<b>Docket Number:</b>	07-AFC-06C
<b>Project Title:</b>	Carlsbad Energy Center - Compliance
<b>TN #:</b>	203084
<b>Document Title:</b>	Supplemental Responses to Data Requests in Set One (Nos. 28-30)
<b>Description:</b>	N/A
<b>Filer:</b>	Dee Hutchinson
<b>Organization:</b>	Locke Lord LLP
<b>Submitter Role:</b>	Applicant Representative
<b>Submission Date:</b>	9/19/2014 3:30:27 PM
<b>Docketed Date:</b>	9/19/2014

Re: Carlsbad Energy Center Project Petition to Amend (07-AFC-06C)  
Project Owner's Supplemental Responses to Data Requests in Set One (Nos. 28 - 30)

## Data Response Set 1 Supplement (Supplemental Responses to Data Requests 28 to 30)

**Figure DR29-3**  
**Ultimate Arrangement**  
 Amended Carlsbad Energy Center Project  
 Carlsbad, California (07-AFC-06C)  
 Petition to Amend

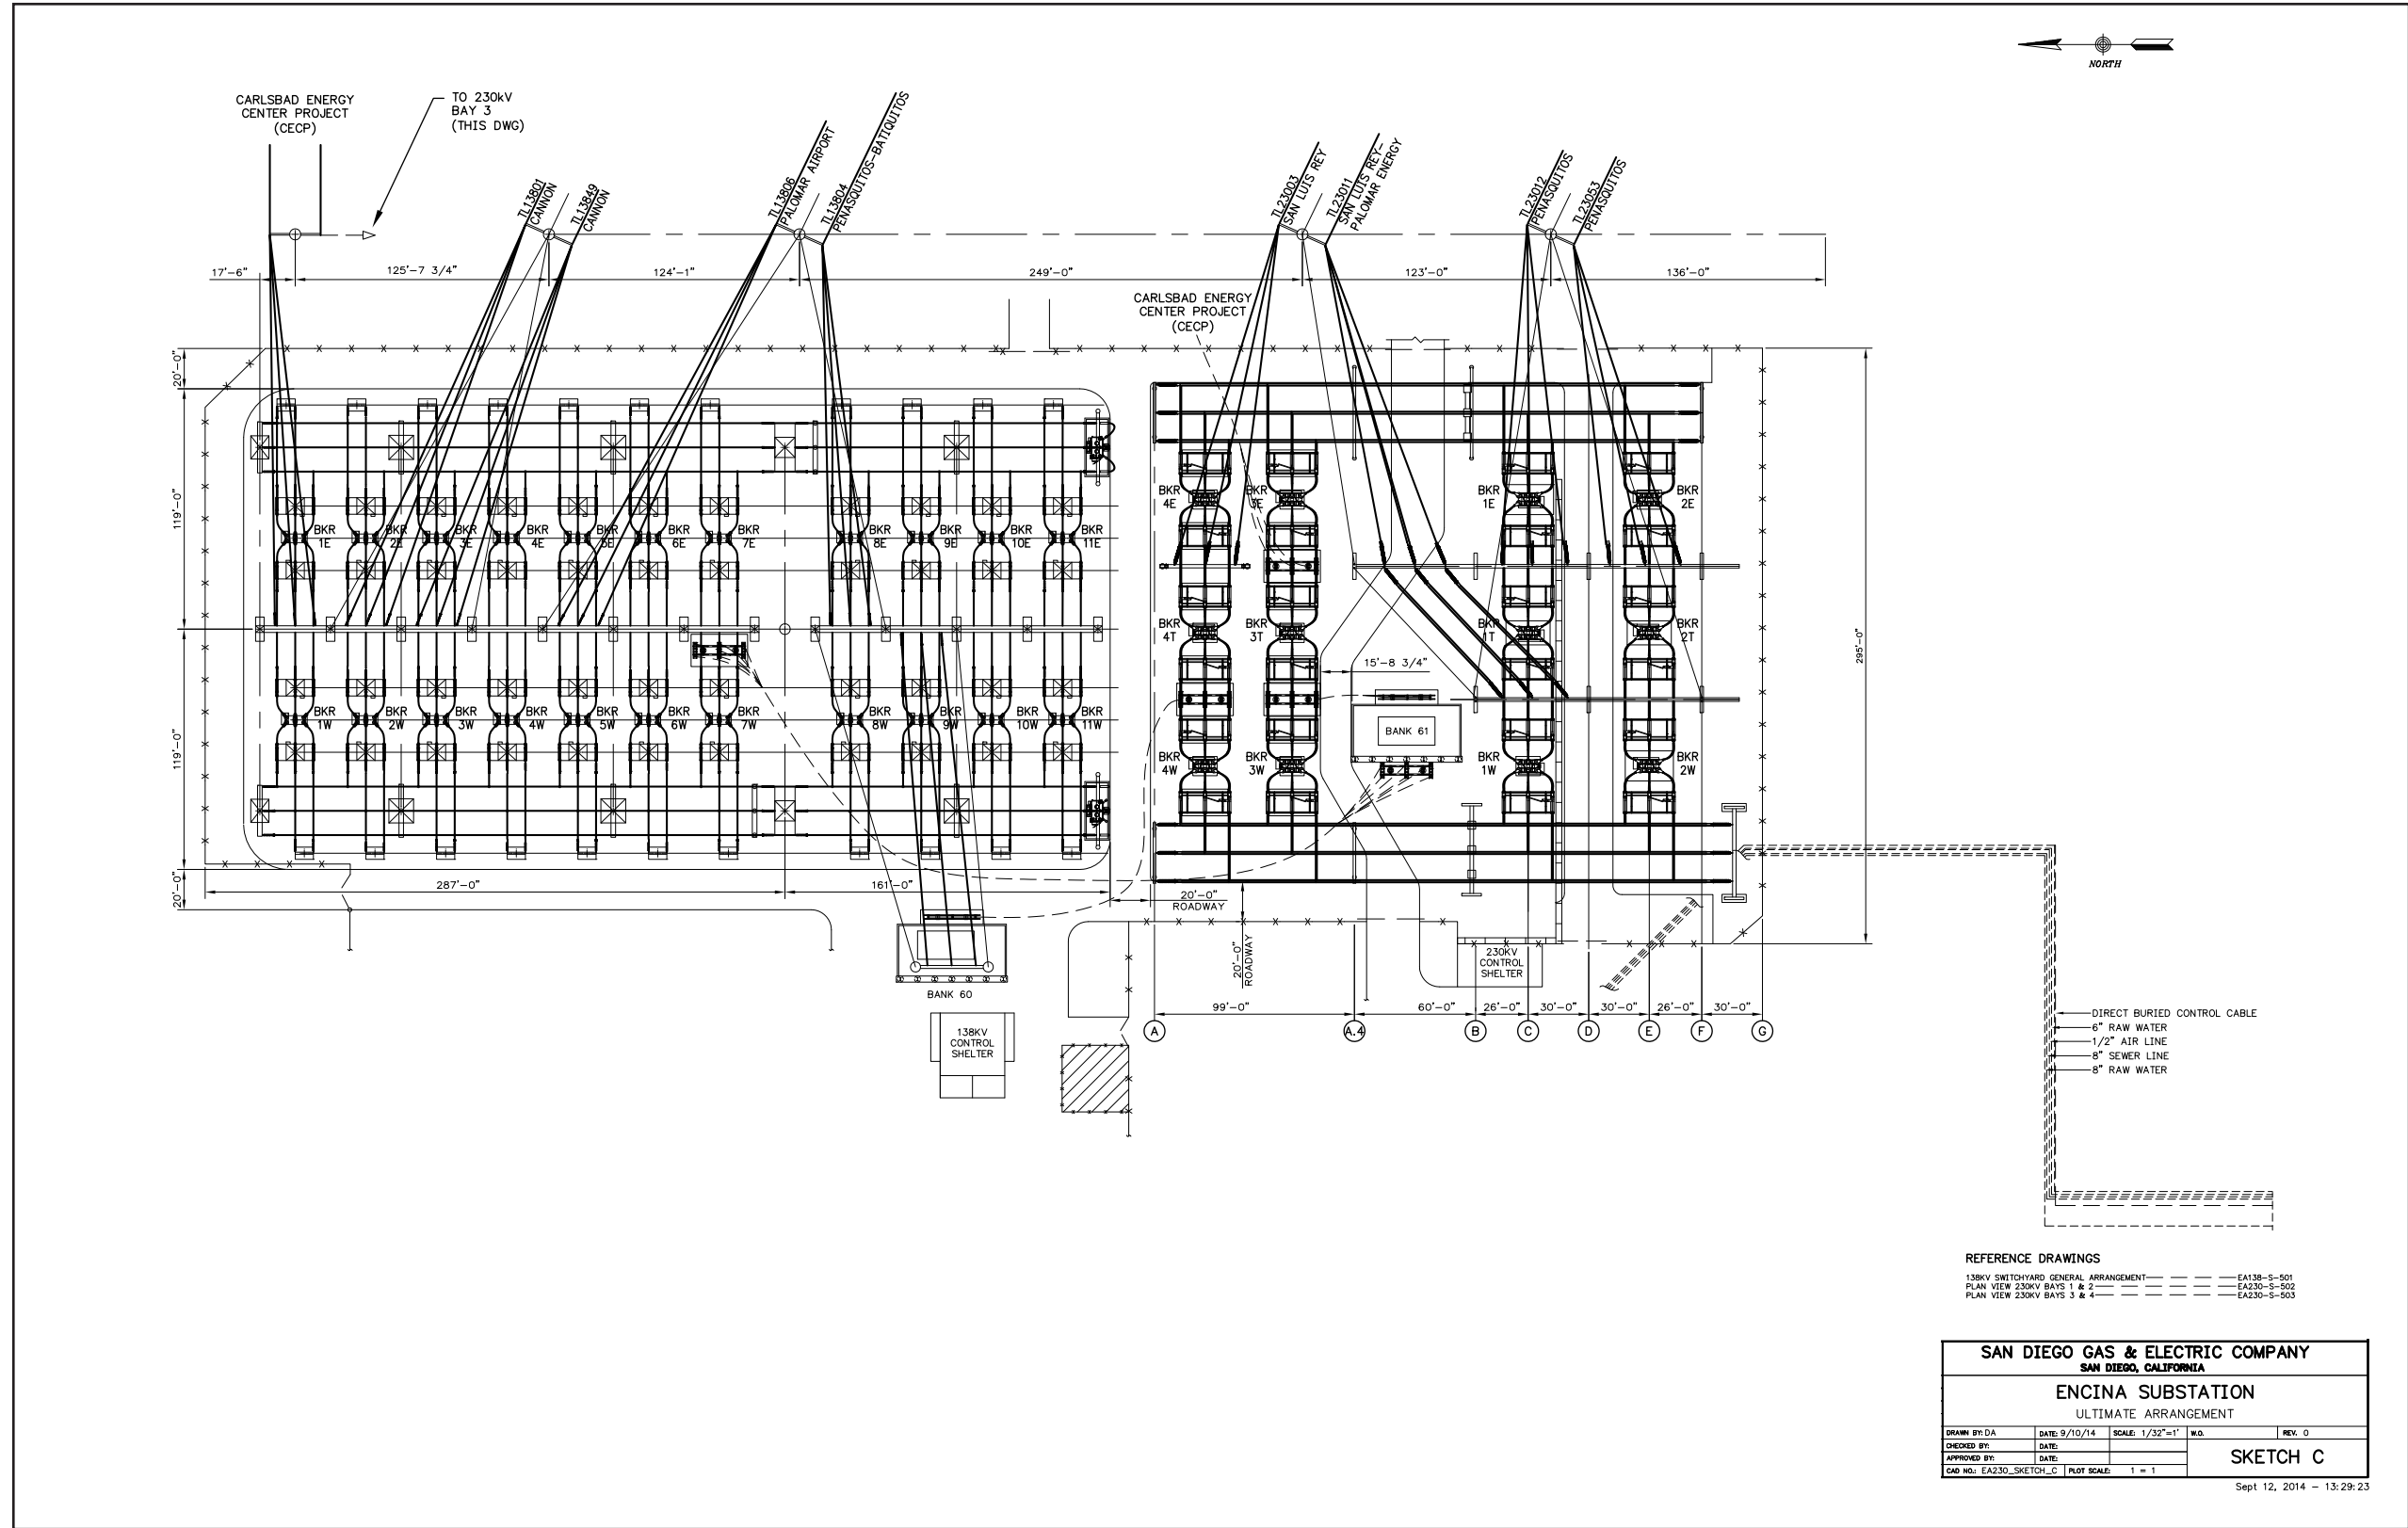
29. Provide pre and post-project physical layout drawings of the SDG&E EPS 230 kV and 138 kV switchyards, with all transmission outlets.

**Response:** A drawing of the post-Commercial Operation Date, general physical layout of the SDG&E 230kV and 138kV switchyards are enclosed as Figure DR29-2. The general final arrangement drawing for the 138/230kV switchyards are enclosed as Figure DR29-3.
